# BENSON PV CABINET HEATERS

## NEW FAN CONTROL / LIMIT STAT RETROFIT

Document reference number TB/091B/0315  
Replaces TB/091B/0114

**1: Remove original Honeywell fan control/limit stat:**

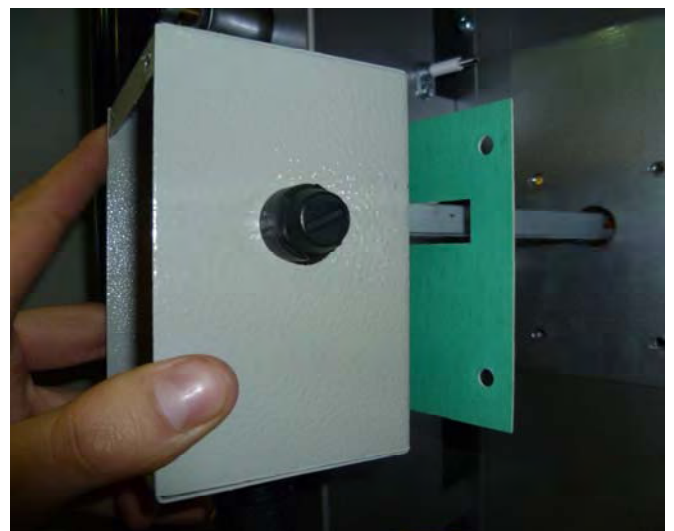
Remove single retaining screw securing the lid of the original fan/limit stat as shown.

Disconnect the five cables (black, red, grey, blue and earth) by releasing the quick connectors with a screwdriver as shown.

*Note: The earth cable ring crimp will need to be cut off and discarded.*

Unscrew and withdraw cable gland (save for later), then remove fixing screws then remove unit from heater.

**2: Fit replacement fan control/limit stat assembly models 120-145:**

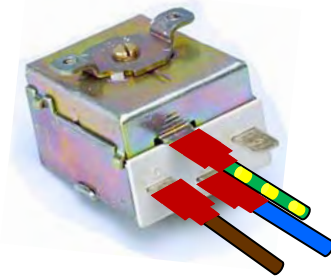
Slide gasket over sensing tube as shown. Fit assembly into original hole.

Fix in position using the original holes.

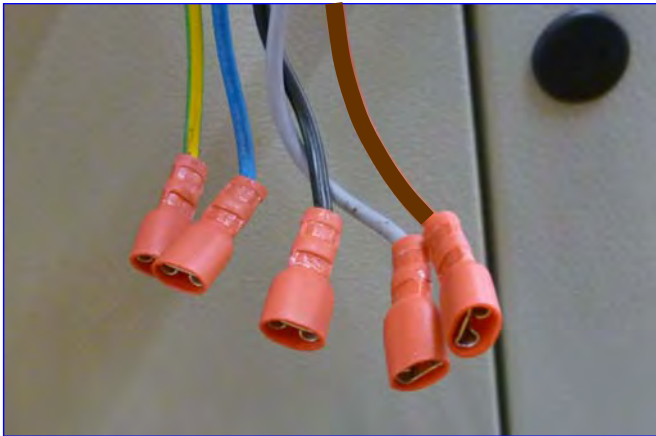
Fan control thermostat wiring connections

Overheat thermostat wiring connections

Fit lid to box using 4 screws provided

Fit the supplied female spade crimps to the original cables .

Fit original cable gland into new assembly and connect new fan control/limit thermostats as follows:

- Fan control thermostat: **BROWN to terminal C**  
**BLUE to terminal 2**  
**GRN/YEL to Earth terminal**
- Overheat thermostat: **BLACK to terminal 2**  
**GREY to terminal 2**

#### 4: Overheat thermostat reset:

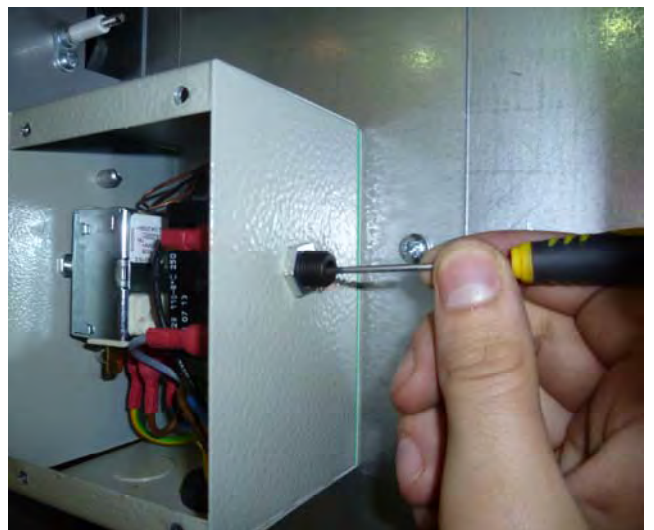
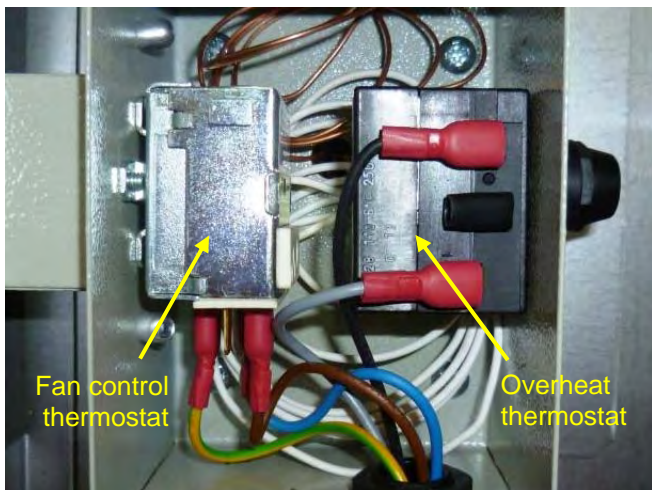
In the event of the overheat thermostat tripping, once the cause has been remedied, it can be reset by removing the protective screw cap, then pushing in the green button as shown below.

**5a: Fitting replacement fan control/limit stat assembly models 72-95:**

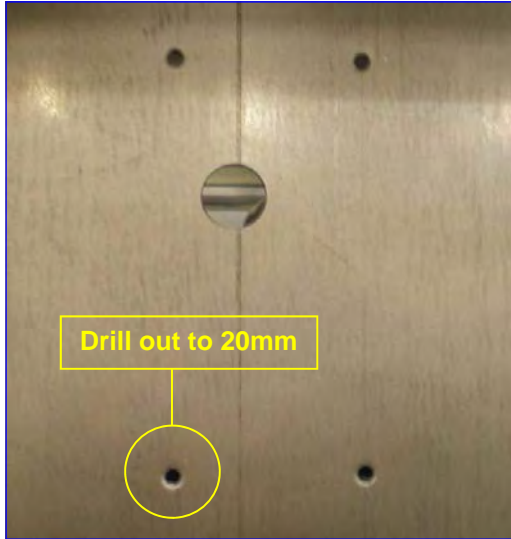
The fitting method for these models is the same as previously described except the addition of an adapter plate, to be fitted as follows: The picture below shows the original holes with bracket and original Honeywell removed.

The bottom left hole should be drilled out to 20mm.

The adapter plate (outlined for clarity) is fitted using the top two existing holes as shown.

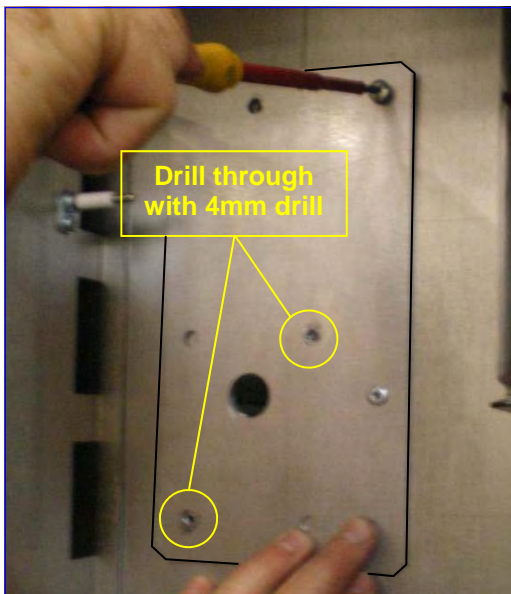
The two diagonal holes shown below should be drilled out to 4mm for the replacement fan/limit stat.

Continue fitting replacement overheat/fan stat as previously described.

**5b: Fitting replacement fan control/limit stat assembly models 30-50:**

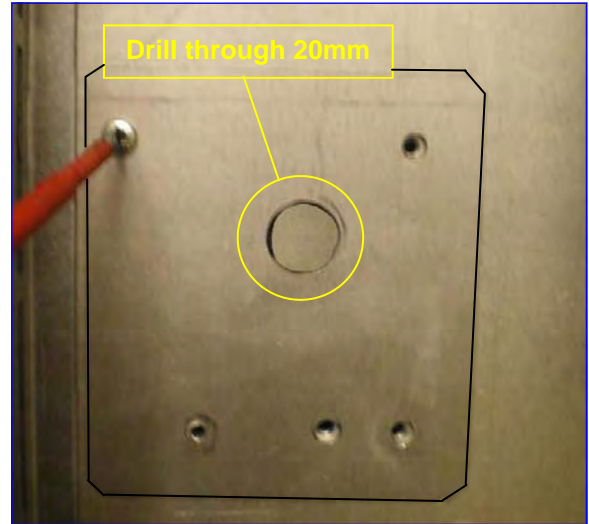
The fitting method for these models is the same as previously described except the addition of an adapter plate, to be fitted as follows:

With the 20mm hole in the adapter plate (outlined for clarity) facing toward the top and the right hand side, fix into place using the existing top left hole, then using as a template, drill through the heater casing using a 20mm hole cutter as shown.

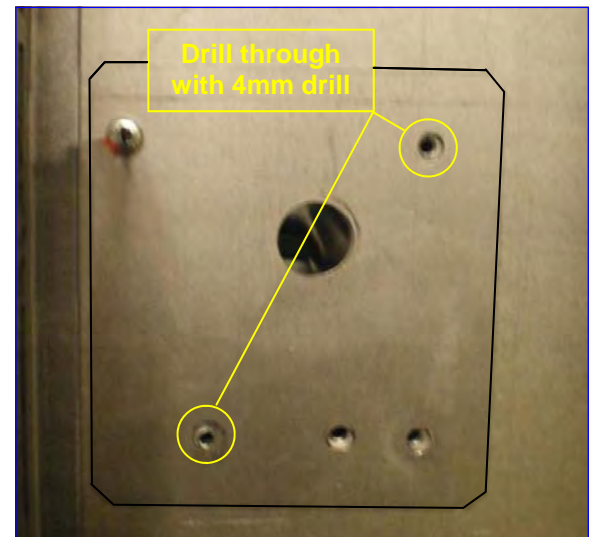
Drill two 4mm holes diagonally as shown for the replacement fan/limit stat.

Continue fitting replacement overheat/fan stat as previously described.
